CITY OF ALBUQUERQUE

RE: 1317 Bellrose Ave NW
Grading and Drainage Plan
Engineer's Stamp Date: 03/10/24
Hydrology File: F14D084

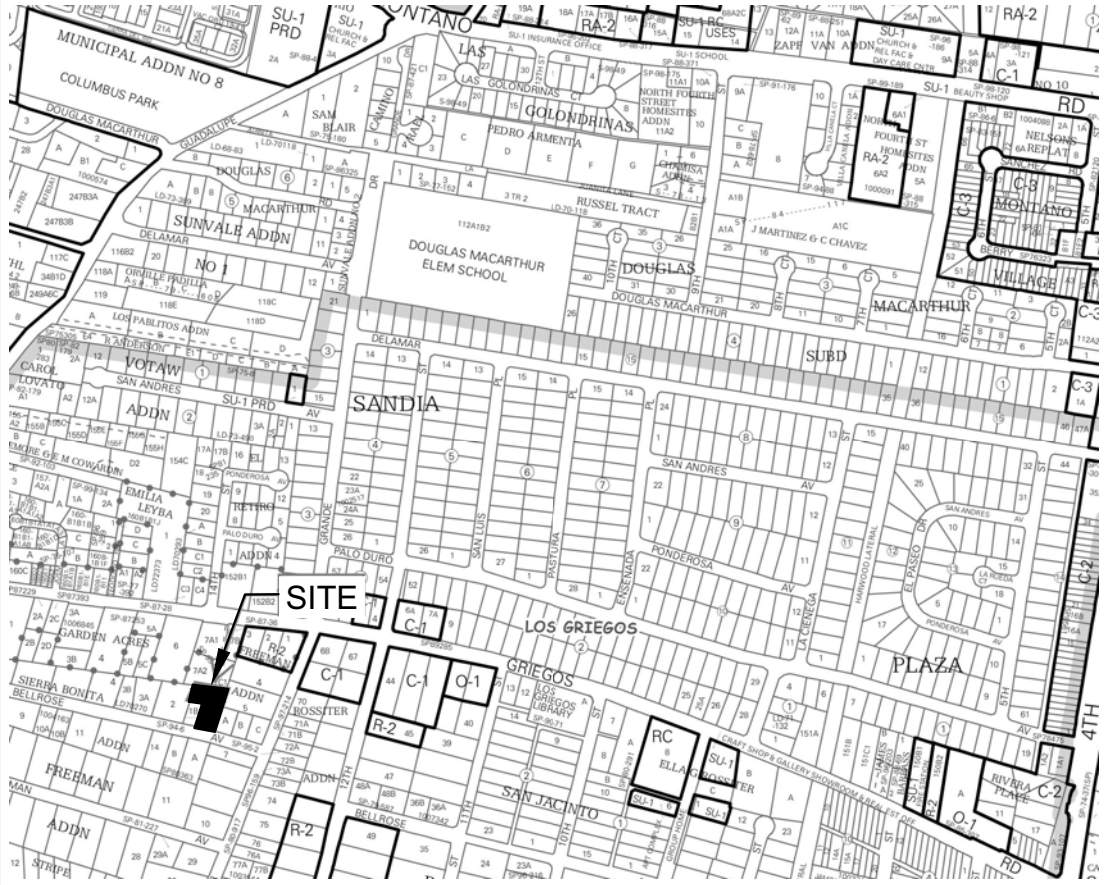
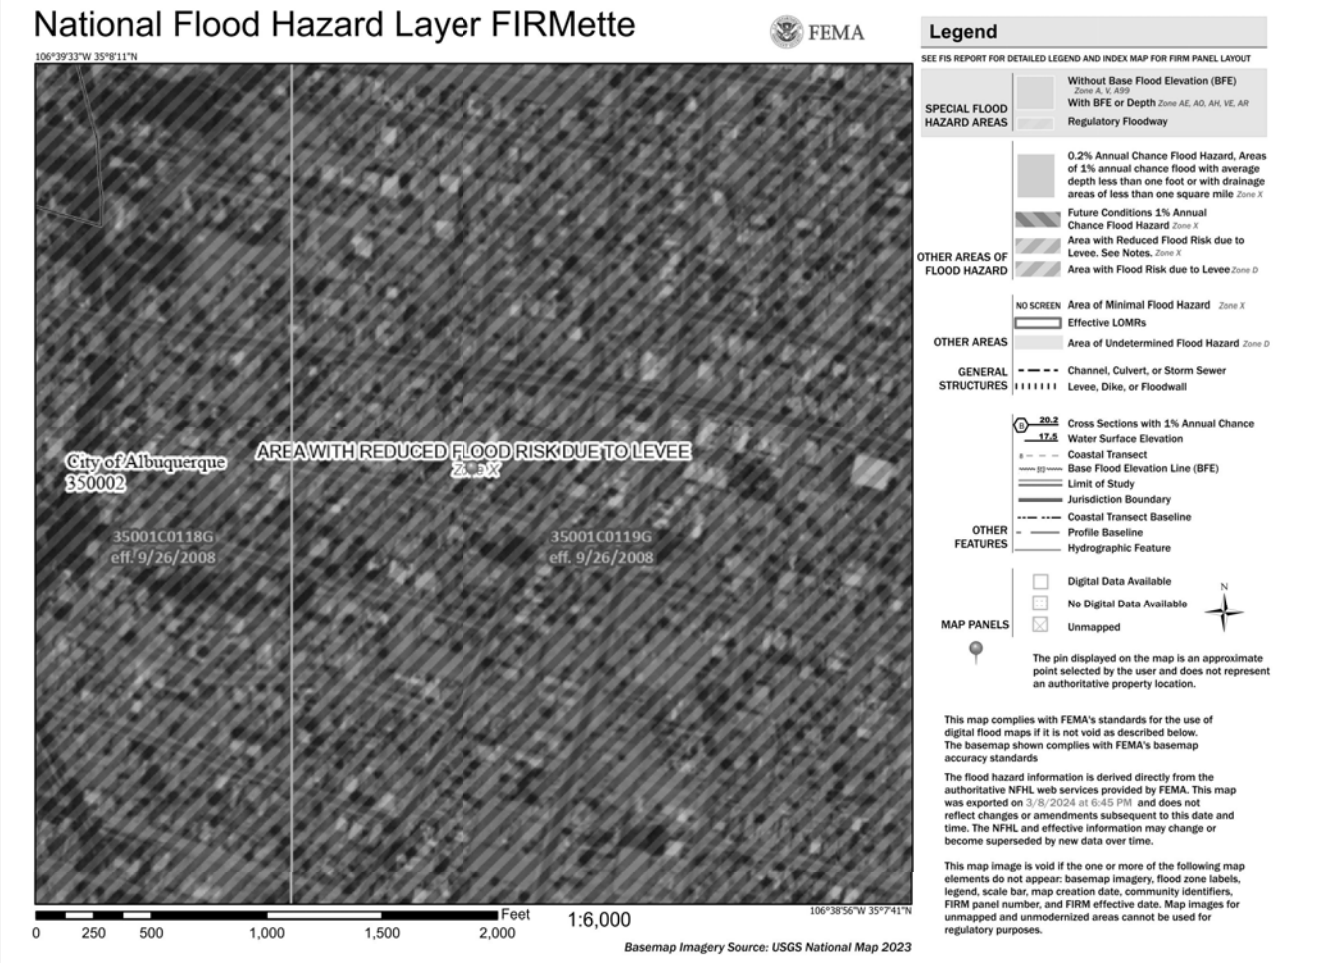
Based upon the information provided in your submittal received 03/11/2024, the Grading and Drainage Plan is approved for Building Permit and Grading Permit. **Since this site currently has an existing house, a pad certification is not needed for this project.** Please attach a copy of this approved plan in the construction sets for Building Permit processing along with a copy of this letter.

1. Engineer's Certification, per the DPM Part 6-14 (F): *Engineer's Certification Checklist For Non-Subdivision* is required.
